H. T. HARVEY & ASSOCIATES

January 26, 2021

Subject: 2300 Calle de Luna – November 2020 Updated Avian Collision Risk Assessment
(HTH #3953-02)

Figure 2. The proposed market-rate apartment building includes extensive glazing, but mullions, opaque wall panels, spandrel, and overhangs increase the visibility of the building to birds. Vegetated areas located on amenity decks above Level 1 are highlighted in green.

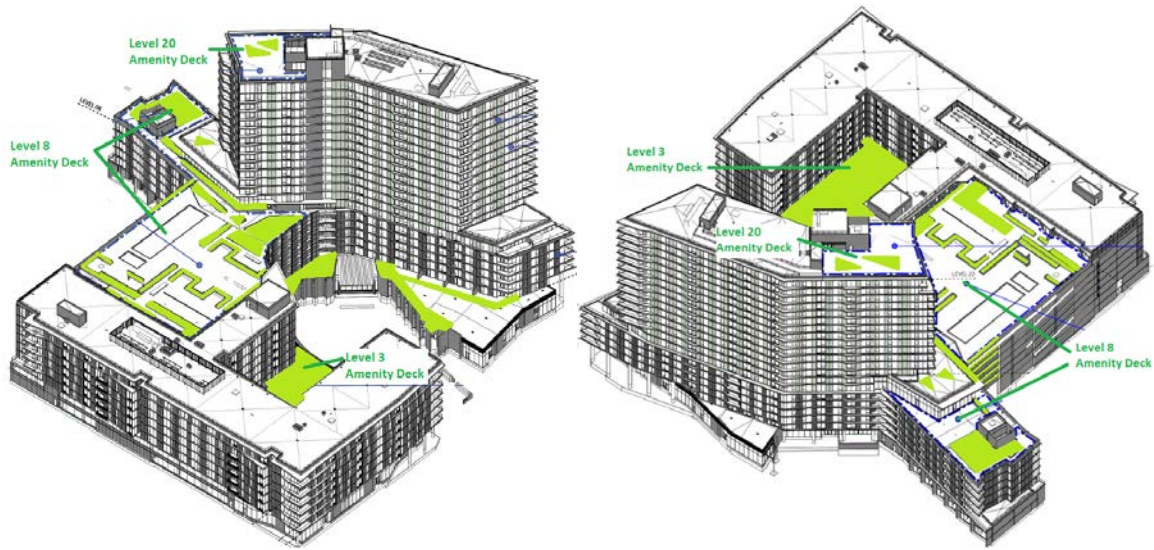
The design of the buildings' façades includes overhangs, opaque wall panels, and mullions that are expected to increase the visibility of the buildings to birds and reduce the potential for birds to collide with the buildings (Figures 2 and 3). Store front areas along Calle del Sol and Calle de Luna will also incorporate an adjacent trellis or an overhead canopy in some areas, which will also increase the visibility of these areas to birds and reduce the potential for bird collisions.

Figure 6. Proposed landscape vegetation at the wandering garden (upper left), Level 20 amenity deck (upper right), outdoor dining terrace (lower left), and private terraces (lower right) of the home for the ambulatory aged.

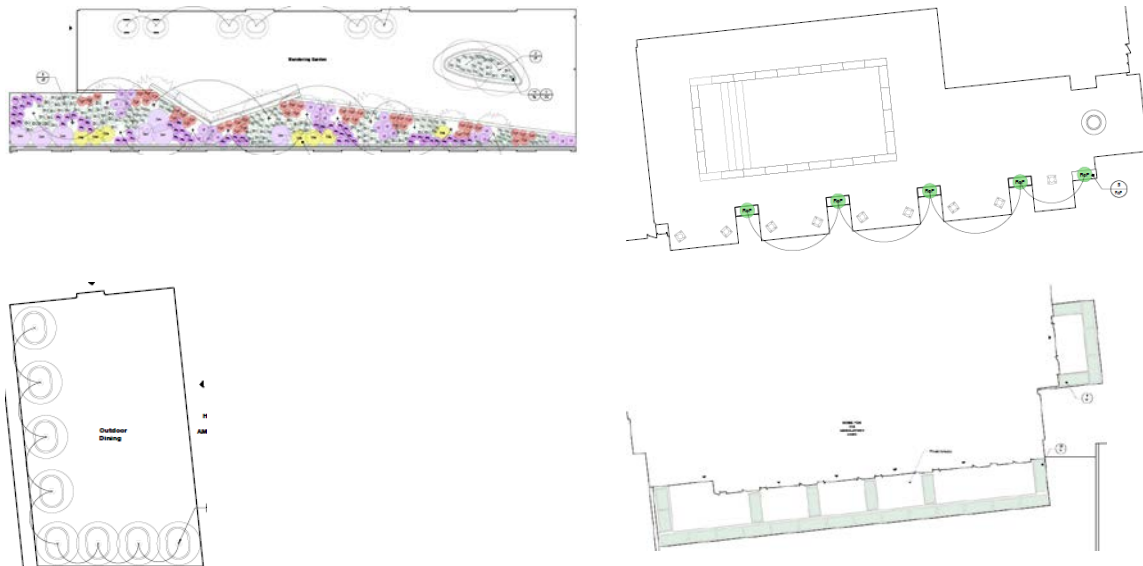
- Due to the extent of the vegetation present in the wandering garden on Level 3, birds may be drawn into this courtyard where they would be surrounded by glazing and experience a higher probability of collisions. Due to this hazard, we recommend that no more than 10% of the facades surrounding the courtyard (combined) consist of untreated glazing, and all untreated glazed areas (i.e., the 10% untreated areas) are broken up into sections no greater than 24 square feet in size by mullions or bird-safe glazing treatments.

- Due to the limited extent of vegetation proposed on Level 20 of the building, it is our opinion that no bird-safe treatment is needed to reduce the potential for collisions due to the presence of this vegetation.

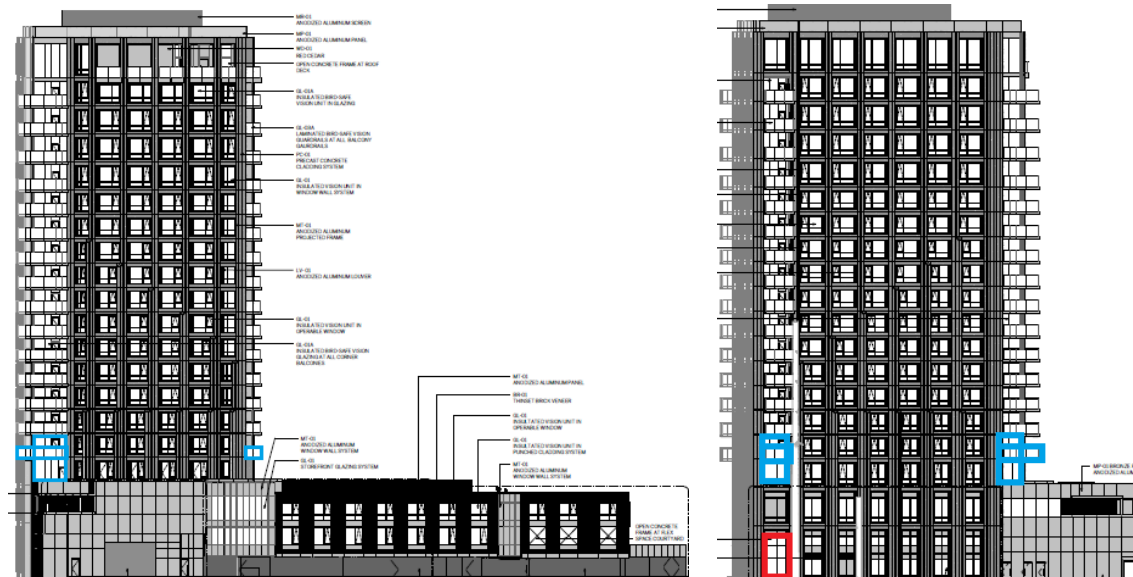
- All feature-related hazards within 60 feet of vegetated areas (i.e., on Levels 1–5) should be treated with a bird-safe glazing treatment¹. A review of the project plans indicates that feature-related hazards in these areas include transparent glass corners and free-standing glass railings (indicated in blue on Figures 7 and 8). All transparent glass railings on these levels should be 100% treated with a bird-safe glazing treatment. It is our understanding that building features such as concrete columns may limit visibility through certain transparent glass corners; accounting for these features, transparent glass corners only need to be treated where it is possible to see through from one side of the corner to the other (as determined by the design team).

- Due to a high potential for bird collisions with glazing on the lower levels of the north, east, and west facades of the building², which will be located adjacent to landscape vegetation (Figure 4), areas of extensive glazing (indicated in red on Figures 7 and 8) should be treated with a bird-safe glazing treatment such that no more than 10% of the surface area of these façades (combined) have untreated glazing, and all untreated glazed areas (i.e., the 10% untreated areas) are broken up into sections no greater than 24 square feet in size by mullions or bird-safe glazing treatments. Because no vegetation is proposed adjacent to facades on the south side of the building, this measure is not required for that façade. Note that any feature-related hazards (transparent glass corners and free-standing glass railings) should be 100% treated and therefore should not be included in the 10% of the surface area that is untreated.

Figure 9. Extensive areas of glazing on Levels 1–2 of the south façade of the mid-rise building are indicated in red, and feature-related hazards (transparent glass railings and building corners) are indicated in blue. These areas should be treated with a bird-safe glazing treatment.

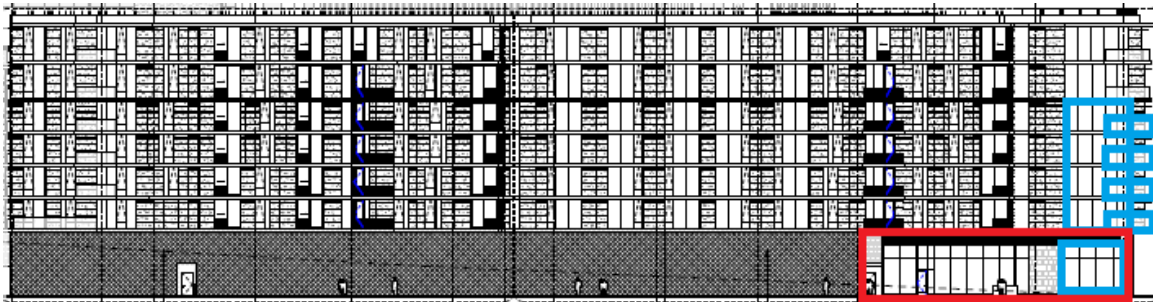
- All extensive glazing on Levels 1–2 above vegetated areas on Level 3 of the mid-rise building (indicated in red on Figures 9–14) should be treated with a bird-safe glazing treatment such that no more than 10% of the surface area of these façades have untreated glazing, and all remaining untreated glazed areas should be broken up into sections no greater than 24 square feet in size by mullions or bird-safe glazing treatments. Feature-related hazards (transparent glass corners and free-standing glass railings) should be 100% treated and therefore should not be included in the 10% of the surface area that is untreated.

Roofs with landscape vegetation are proposed on Levels 3, 8, and 23 of the market-rate apartments (Figure 2) and Levels 2, 3, and 20 of the home for the ambulatory aged (Figure 3). In addition, a green wall is proposed on the lower levels of the southern façade of the midrise (Figure 9). As discussed under requirement #5 above, glazing on the building is broken up by opaque wall panels and spandrel glazing in areas adjacent to proposed landscape vegetation on rooftops. The glazing on the southern façade of the midrise is similarly broken up by opaque wall panels and spandrel glazing adjacent to the green wall (Figure 9). Where glazing is more extensive adjacent to vegetated rooftops and green walls, those areas should be treated with a bird-safe glazing treatment, as indicated on Figures 7–14 above. With the implementation of these recommendations, it is our opinion that the project is in compliance with this requirement.

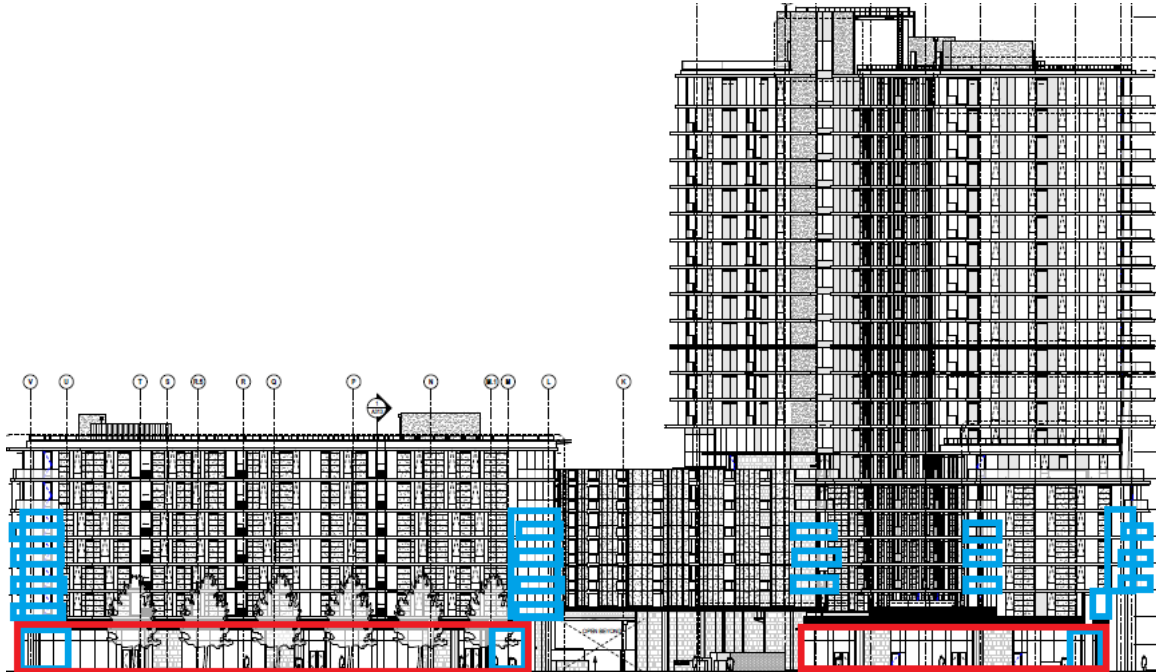
- All feature-related hazards on balconies/patios within 60 feet of the ground (i.e., on Levels 1–5) above landscape vegetation and within 60 feet above large vegetated areas on rooftops (i.e., above the Level 3 amenity terrace) (indicated in blue on Figures 9–14) should be treated with a bird-safe glazing treatment. In our opinion, portions of glazing on feature-related hazards that are located immediately behind a trellis (e.g., along the ground-level retail area) do not need to be treated.

Figure 12. Extensive areas of glazing on Levels 1-2 of the west façade of the apartment tower (left) are indicated in red, and feature-related hazards (transparent glass railings and building corners) on the west façade of the apartment tower and mid-rise building (right) are indicated in blue.

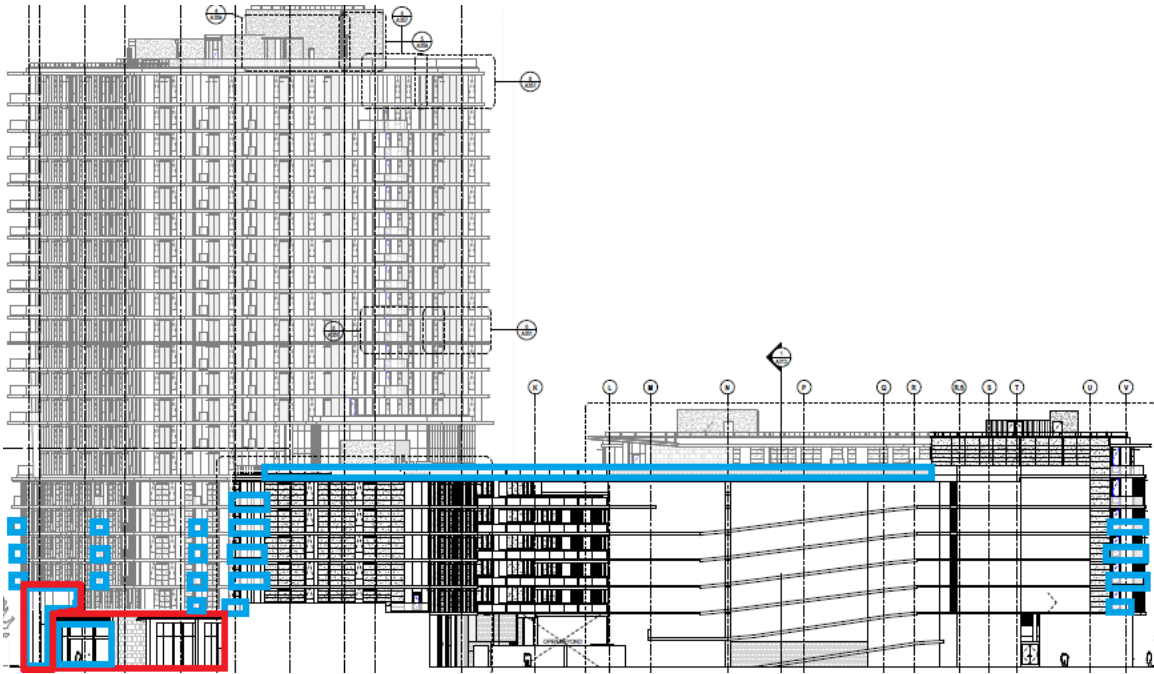
- All feature-related hazards adjacent to open space areas on Level 8 should be treated with a bird-safe glazing treatment (Figures 11 and 12).
